ADDENDUM NO. 2

Venetia Valley TK-8 School Landscape Renovations

Project Number #25-03

Addendum Date: March 20, 2025

SHEET NUMBER
ADDENDUM 2
L3.1

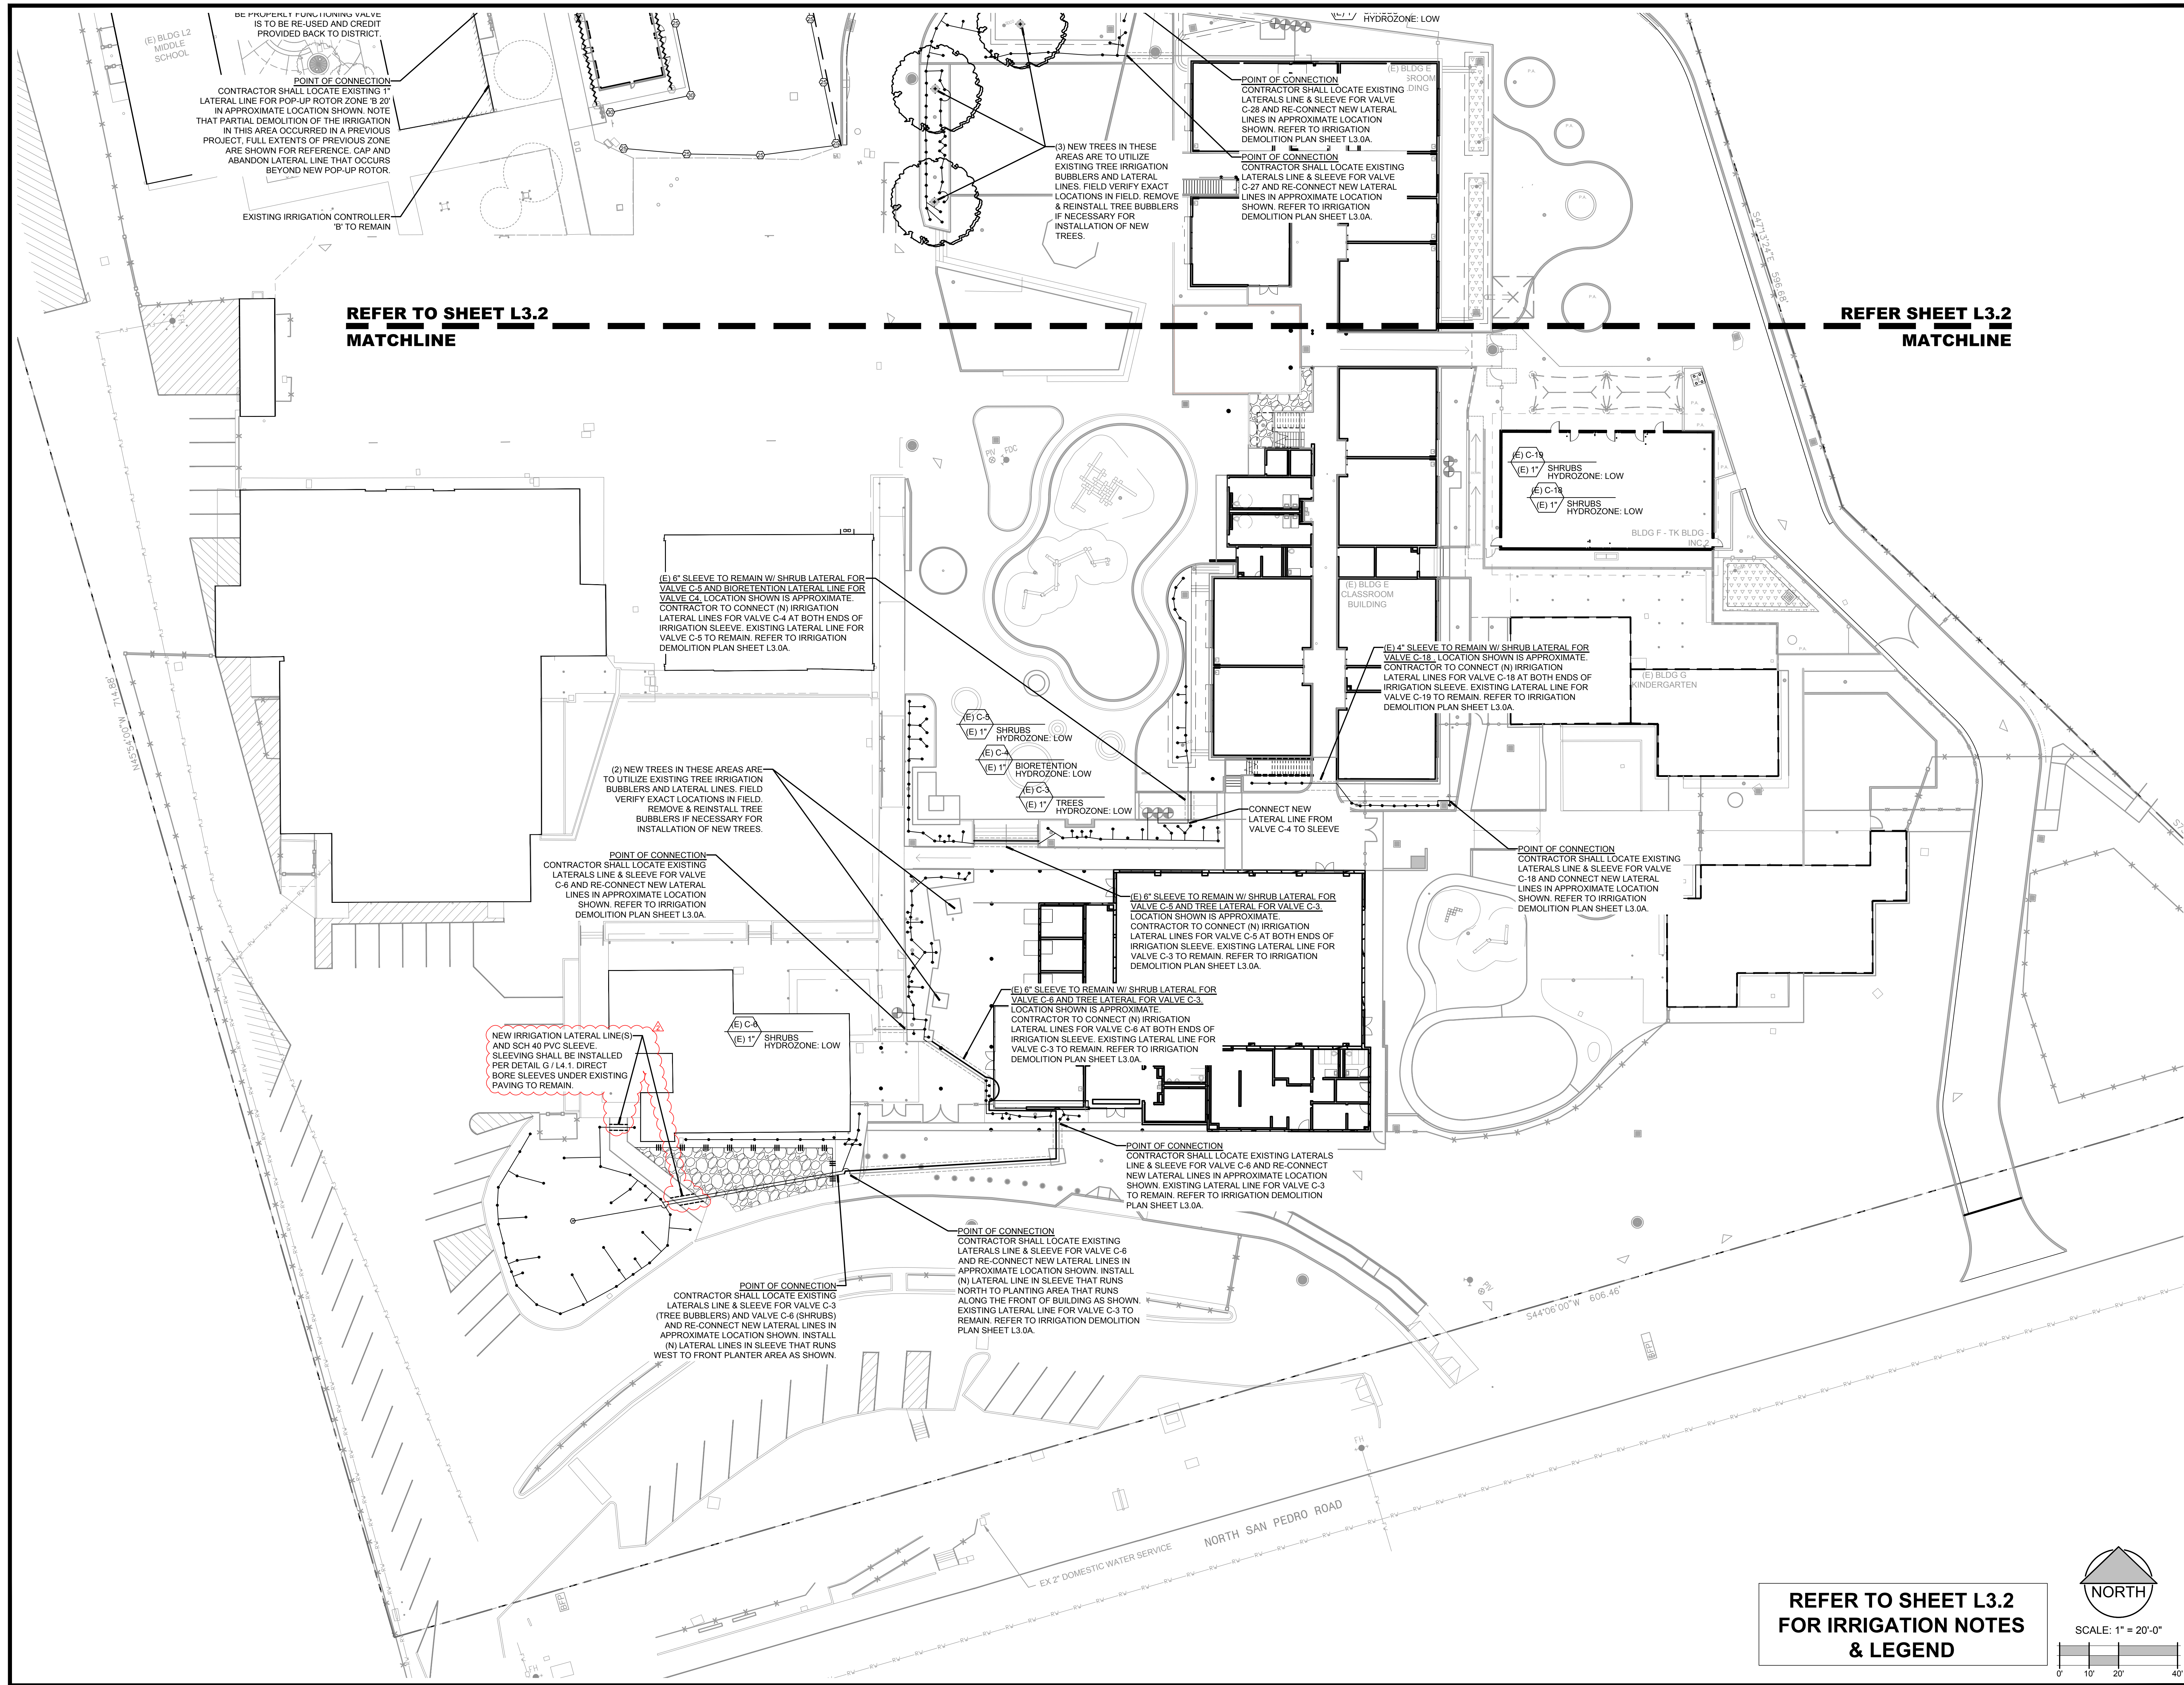
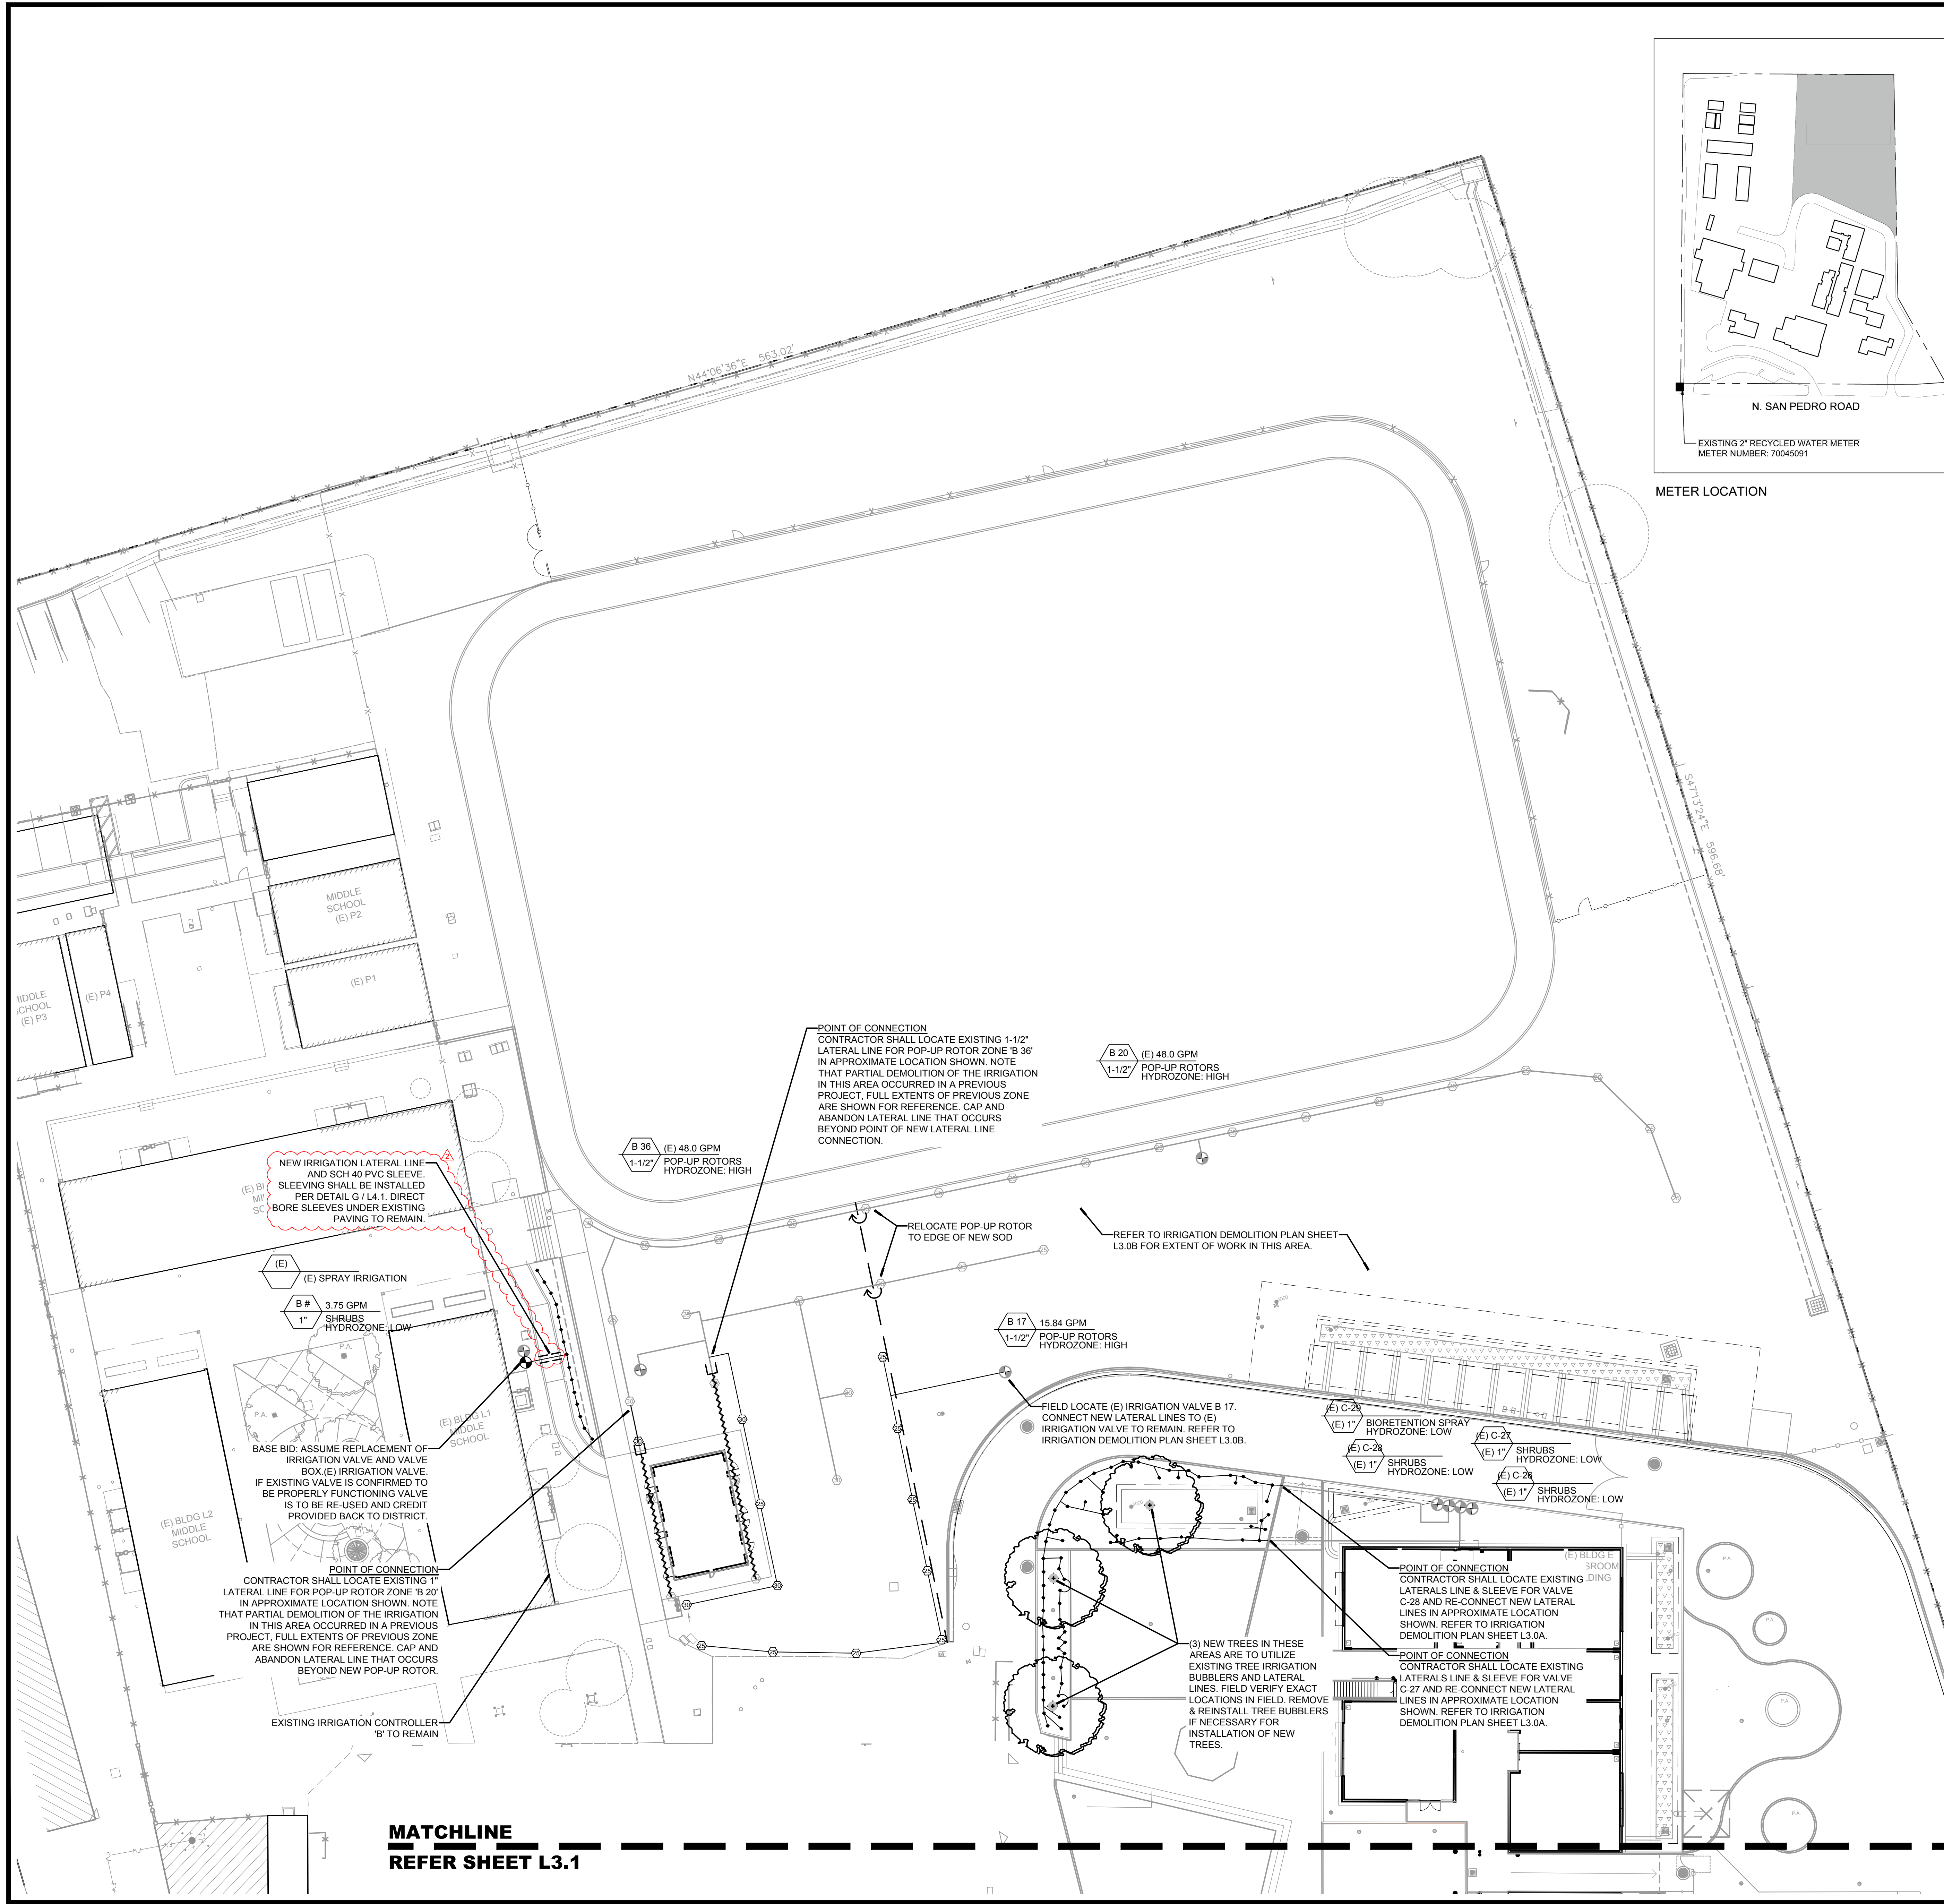
20. Question Received: “L3.1 shows new sleeves (bold) and existing sleeves (not bold) but calls all the sleeves and laterals inside the sleeves as existing. Are all the sleeves existing? And laterals within the existing sleeves existing?”

ITEM NO. 1.4: SHEET L3.1 IRRIGATION PLAN:

Add: Callout to clarify location of (2) new irrigation lateral lines installed in sleeves that are to be installed via direct bore under existing paving to remain.

- a. Answer: Refer to updated sheet L3.1 and L3.2 provided as part of Addendum 2. Graphics have been updated on the sheets and in the irrigation legend to provide enhanced clarity as to where existing and new irrigation sleeving is to occur. Notes have also been added, clouded on the sheet, specifically labeling the irrigation sleeves that are to be installed as part of this project.

Replace: Sheet L3.1 in its entirety with the attached sheet Addendum 1-L3.2.
